Bejar Village Subdivision

City of El Paso — City Plan Commission — 4/5/2018

SUSU18-00013 — Major Combination

Manor Place

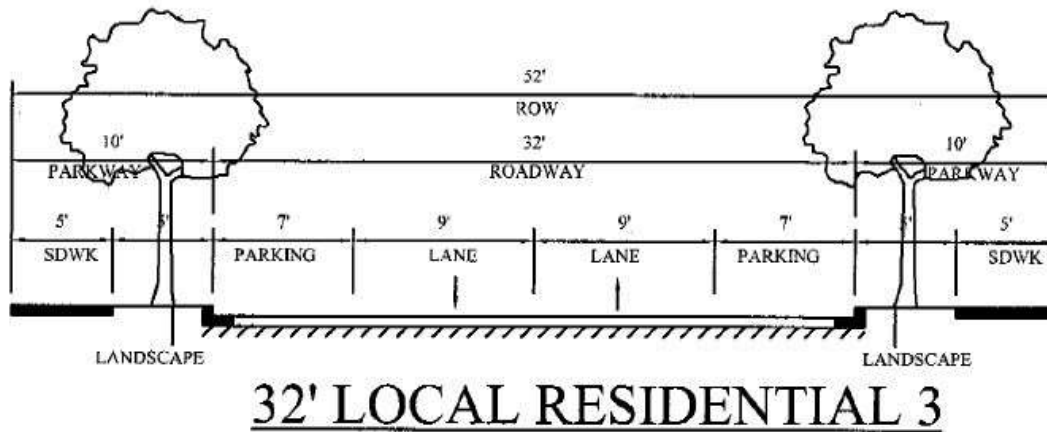
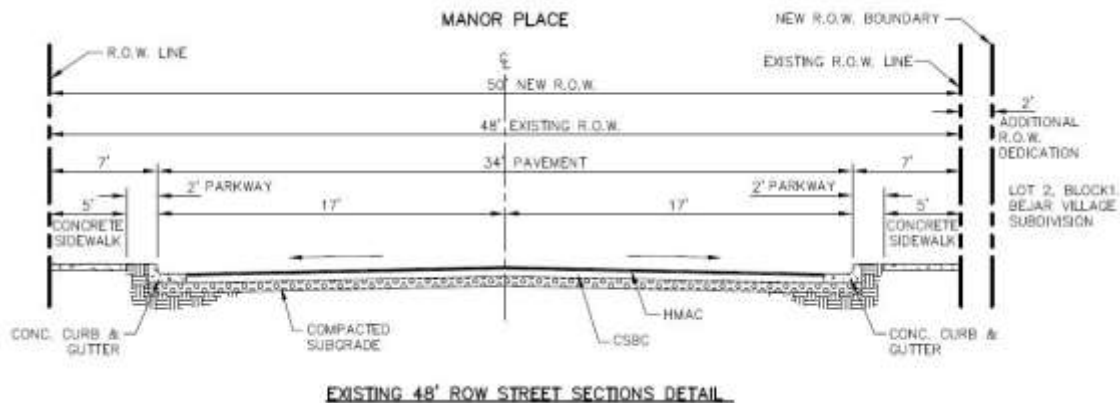
The DSC requires a 10' parkway with a 5' landscape buffer and 5' sidewalk.

The applicant proposes to preserve the existing configuration of Manor Place, which includes a 2' parkway, and 5' sidewalk. In addition, the applicant is proposing to dedicate an additional 2' of ROW, required per the applicant's proportional share of the required 52' ROW. The linear street frontage the proposed subdivision will have along Manor Place is approximately 180 feet.

Barker Road

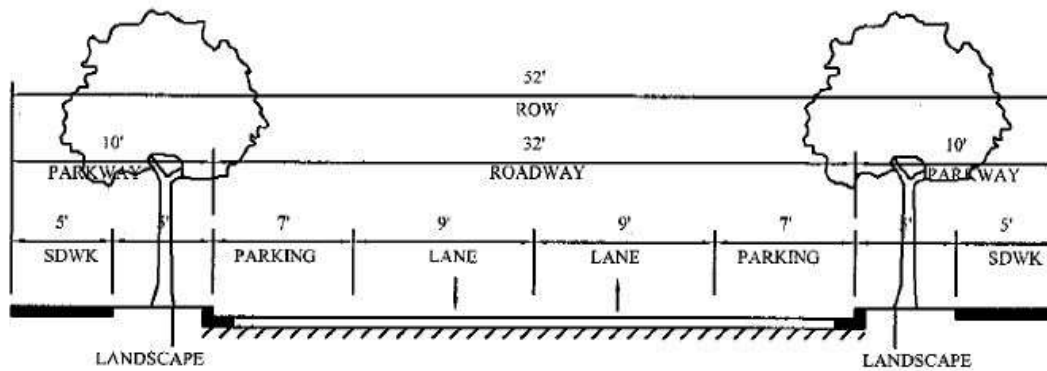
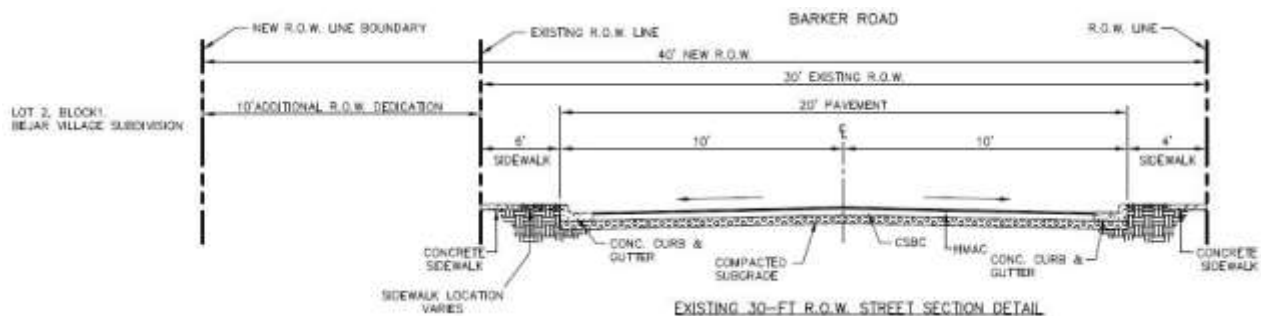
The DSC requires a 10' parkway with a 5' landscape buffer and a 5' sidewalk.

The applicant proposes to preserve the existing configuration of Barker Road, which includes a 6' sidewalk and no landscaping. The applicant is proposing to dedicate an additional 10' of ROW, required per the applicant's proportional share of the required 52' ROW. The linear street frontage the proposed subdivision will have along Barker Road is approximately 35 feet.

Alameda Avenue

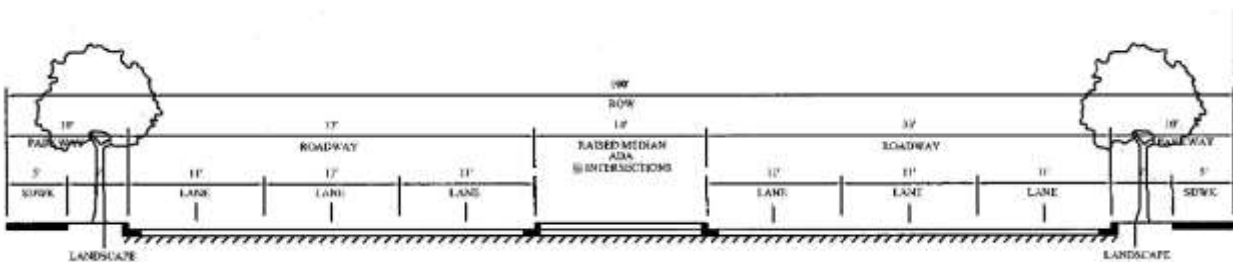
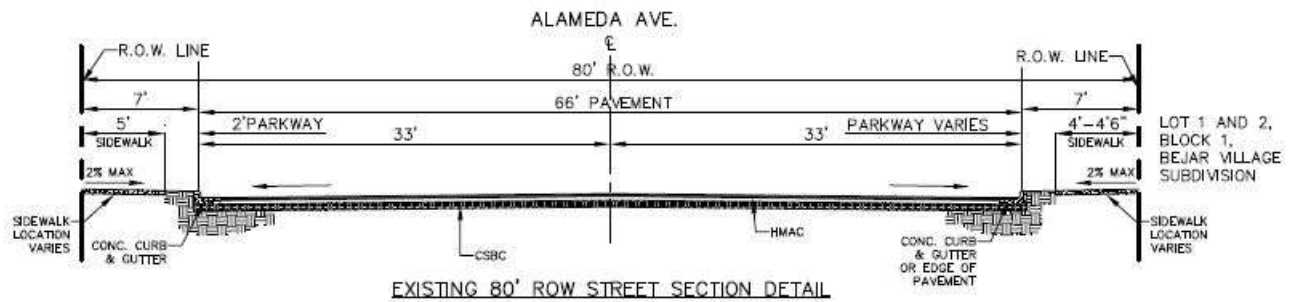
The DSC requires a 10' parkway with a 5' landscape buffer and a 5' sidewalk.

The applicant proposes to preserve the existing configuration of Alameda Avenue, which includes a 5' sidewalk and no landscaping. According to the cross-section, there is two feet of available space that could be used for landscaping. The linear street frontage the proposed subdivision will have along Alameda Avenue is approximately 332 feet.
